National Emission Standards for Hazardous Air Pollutants for Coke Ovens: Pushing, Quenching, and Battery Stacks, and Coke Oven Batteries; Residual Risk and Technology Review, and Periodic Technology Review

ACTION: Final rule.

Figure 2. Regression Of 1981 And 2022 Coke Oven Method 303 Leak Data From Bench-Only And Yard

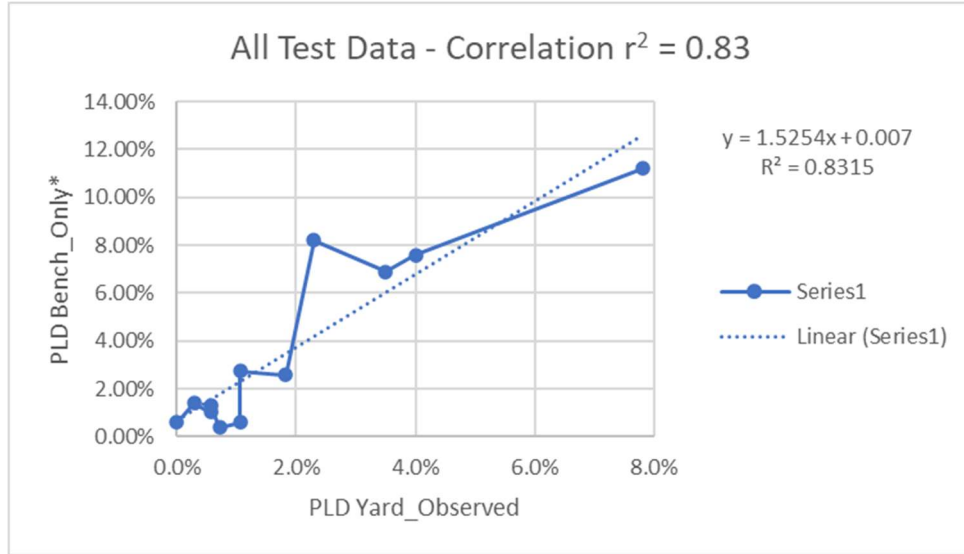
Comment: A commenter stated they believe the EPA's proposed change to the equation for estimating leaks would underestimate PLD_{bench} and thus COE, and proposed an alternative equation. To test the EPA's proposed change, the commenter plotted PLD_{bench} versus PLD_{yard} (shown in this section as Commenter's Figure 1). The commenter asserted that for a valid equation the points should fall along a line with a slope of 0.94 and intercept of 0, and that because data for these four batteries in Commenter's Figure 1 are above this line, the EPA's proposed equation underestimates PLD_{bench} and thus COE.

The commenter continued that another issue is that the EPA's proposed change assumes that PLD_{bench} is zero when PLD_{yard} is zero. However, even when there are no leaks visible from the yard, there will still likely be leaks visible only from the bench. It appears a more appropriate method for estimating PLD_{bench} from PLD_{yard} is to fit a line to the data with a non-zero intercept. Doing so yields the following equation for estimating PLD_{bench} from PLD_{yard} :

Response: We agree with the commenter that there could be PLD from the bench, *i.e.*, PLD bench-only emissions, when PLD from the yard is zero. However, the term PLD_{bench} in the equation in the proposal materials represented emissions from the PLD from bench-only, see pg. 2 of the *Revised Equation to Estimate Coke Oven Emissions from Oven Doors* prepared for the proposal,¹¹ as well as the memorandum prepared for the final rule titled *Revised Equation to Estimate Coke Oven Emissions from Oven Doors-Final Rule*,¹⁶ where it was stated that the PLD_{bench} term was the “percent of doors with leaks only visible from the bench, assumed

In order to determine the value for PLD-bench only when PLD yard is equal to zero, we plotted PLD yard by PLD bench-only, similar to the commenter's approach but using PLD bench-only instead of PLD bench-total. The intercept of the regression line with the y-axis is the value for PLD-bench-only when PLD yard is 0, at 0.7 percent (or a factor of 0.007). The correlation coefficient (r^2) of the regression line is 0.84, which is considered a good fit. See Figure 2 in this section.

The revised door leak equation using the revised ratio of PLD-bench-only to PLD yard of 1.5 and adding a third term in the equation to represent the case where PLD-yard is equal to zero is shown below:
